**PALM BEACH COUNTY  
PLANNING, ZONING AND BUILDING DEPARTMENT  
ZONING DIVISION**

**Application No.:** ZV/DOA-2020-01452  
**Application Name:** The Farms Market Place MUPD  
**Control No./Name:** 1980-00234 (Stephen Watson)  
**Applicant:** Jupiter Burrito Bros LLC  
**Owners:** Jupiter Burrito Bros LLC  
**Agent:** Gentile Glas Holloway O'Mahoney & Associates Inc.  
Pat Lentini & Troy Holloway  
**Telephone No.:** (561) 575-9557  
**Project Manager:** Timothy Haynes, Senior Site Planner

**TITLE:** a Type 2 Variance **REQUEST:** to allow the reduction in width of a compatibility landscape buffer and a landscape island; and, to allow an accessory structure within a front yard. **TITLE:** a Development Order Amendment **REQUEST:** to amend a previously approved Planned Commercial Development to modify the Site Plan; and, add building square footage.

**Figure 5 – Preliminary Regulating Plan dated May 24, 2021**

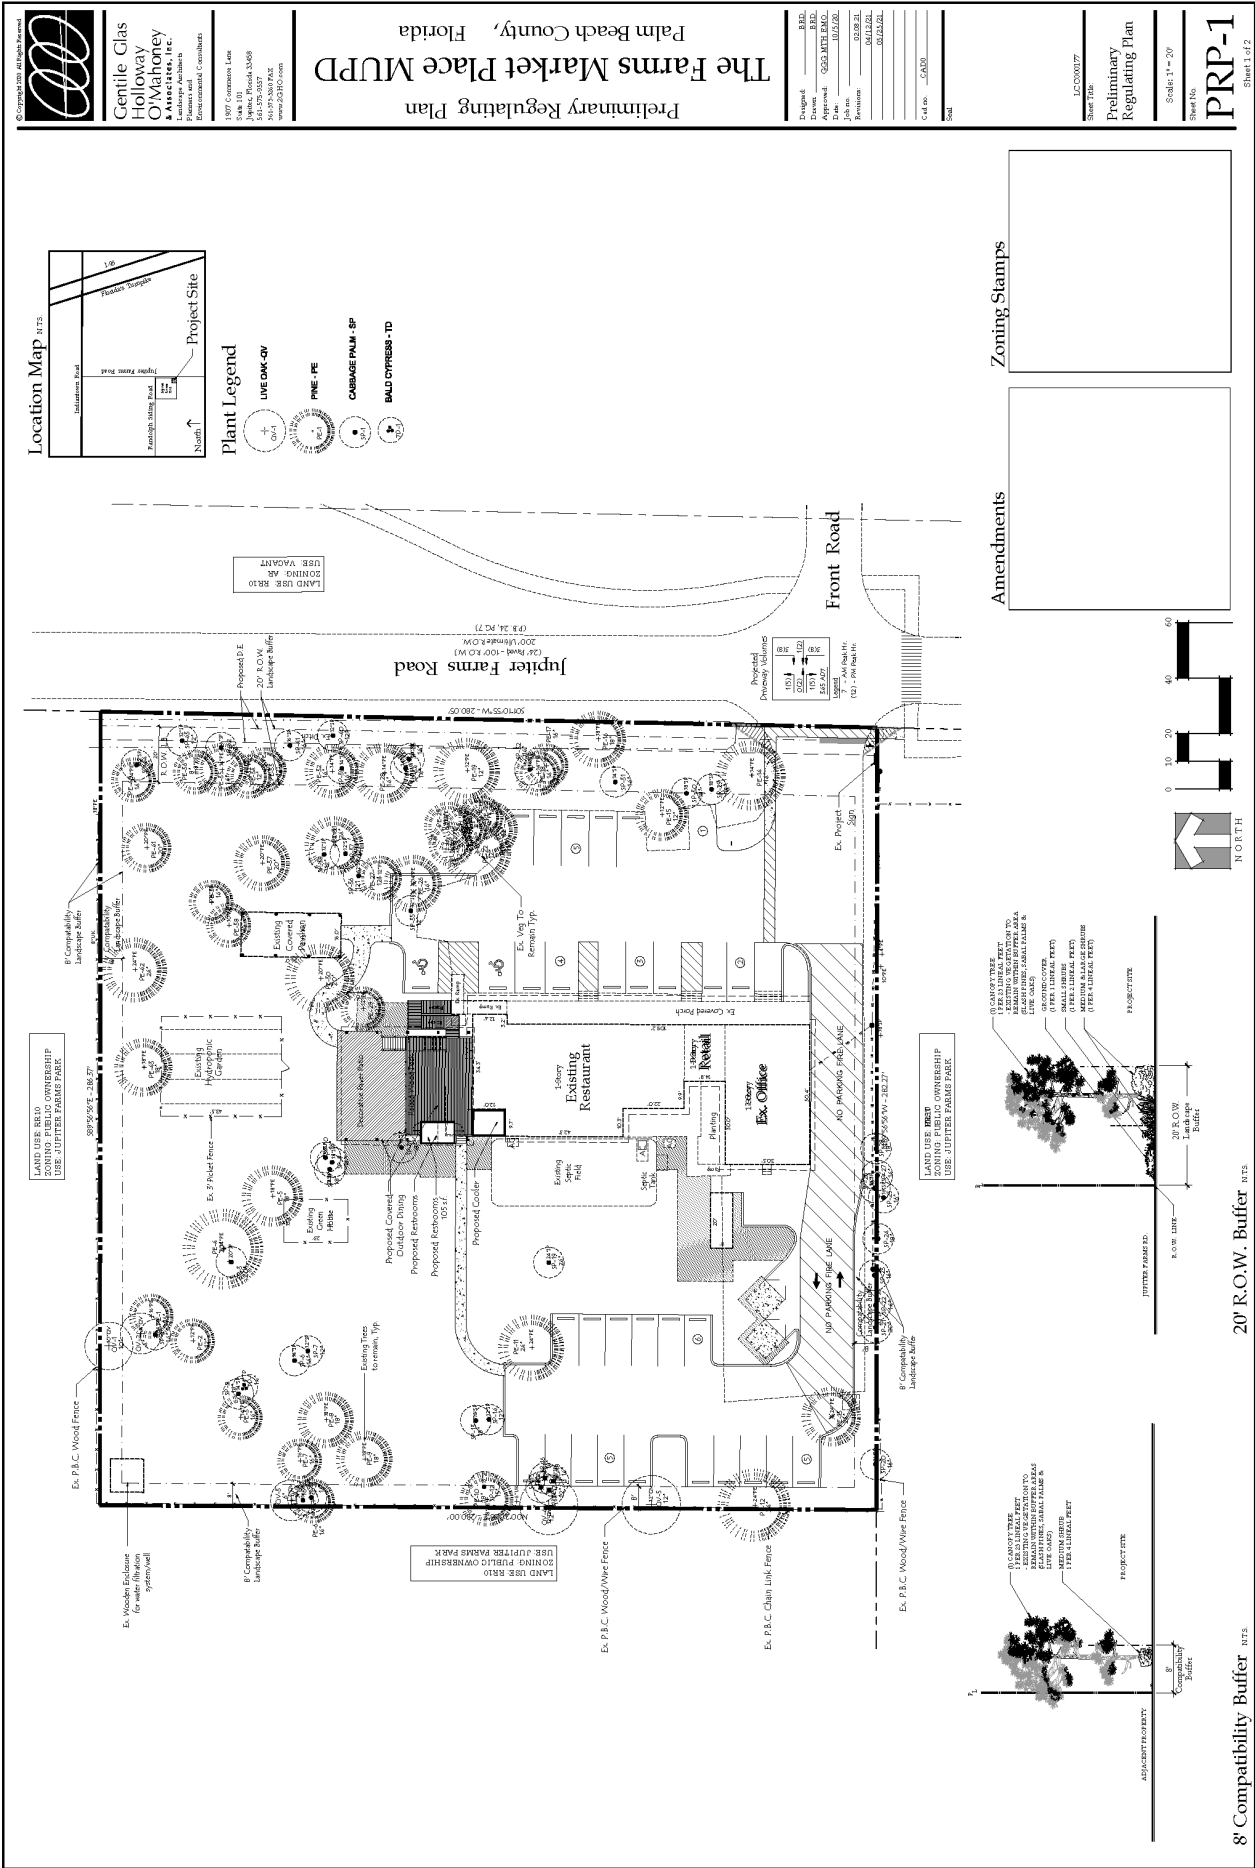
1. Prior to final approval by the Development Review Officer, the final site plan shall be revised to indicate a four foot wide side walk adjacent to the newly installed handicap parking space located on the east side of the proposed raised deck area per Art. 6.B.3.A.d.3, Pedestrian Circulation. (DRO: ZONING - Zoning)
